IloT Product End-of-Life Notice

End of Life, Last Time Buy and Replacement Announcement

For immediately release, Advantech is announcing the End of Life (EOL) of **UNO-2484G series** and related customized P/N. The relative replacing models are as below list. Customers who had purchased this Part Number either to purchase any additional rules or migrate to the new replacement models if possible before the EOL's shipment date.

Product Part Numbers Affected by This Announcement

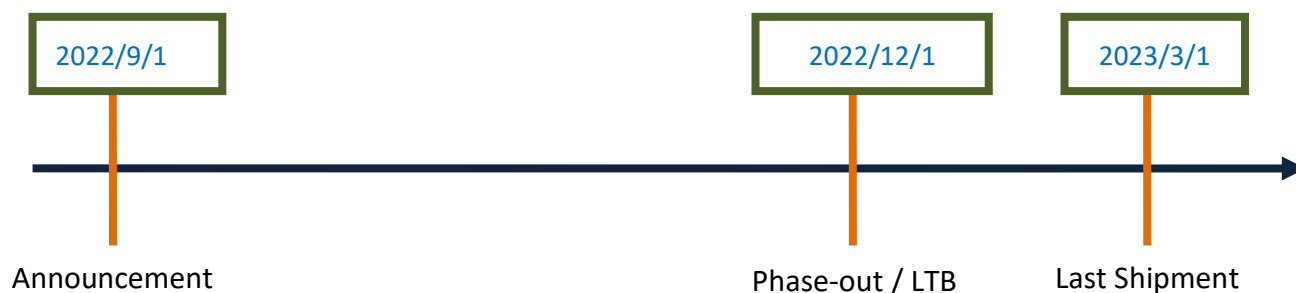
Infineon announced to discontinue the manufacturing and LTB purchasing of power IC PX3517 by 2022/2/1 and no pin to pin replacement product.

In the meanwhile, overall power IC, core chipset component supply is constrained and under shortage. Advantech decided to revise PCB layout to replace the EOL Infineon power IC with alternative and some of critical shortage IC at the same time.

Model	Product Category		Old Model	Replacement Model
UNO-2484G	6th CPU generation	Single stack	UNO-2484G-6331AE	UNO-2484G-6331BE
			UNO-2484G-6531AE	UNO-2484G-6531BE
			UNO-2484G-6731AE	UNO-2484G-6731BE
		Double stack	UNO-2484G-6332AE	UNO-2484G-6332BE
			UNO-2484G-6532AE	UNO-2484G-6532BE
			UNO-2484G-6732AE	UNO-2484G-6732BE
	7th CPU generation	Single stack	UNO-2484G-7331AE	UNO-2484G-7331BE
			UNO-2484G-7531AE	UNO-2484G-7531BE
			UNO-2484G-7731AE	UNO-2484G-7731BE
			UNO-2484G-7C21AE	UNO-2484G-7C21BE
		Double stack	UNO-2484G-7332AE	UNO-2484G-7332BE
			UNO-2484G-7532AE	UNO-2484G-7532BE
			UNO-2484G-7732AE	UNO-2484G-7732BE
	Luxuriant IO Solution		UNO-2484G-6332UAE	N/A (by project)
			UNO-2484G-6532UAE	N/A (by project)
			UNO-2484G-6732UAE	N/A (by project)
	Non-Audio Function Version		UNO-2484G-7331AO	UNO-2484G-7331BE
			UNO-2484G-7531AO	UNO-2484G-7531BE
			UNO-2484G-7731AO	UNO-2484G-7731BE
			UNO-2484G-7C21AO	UNO-2484G-7C21BE
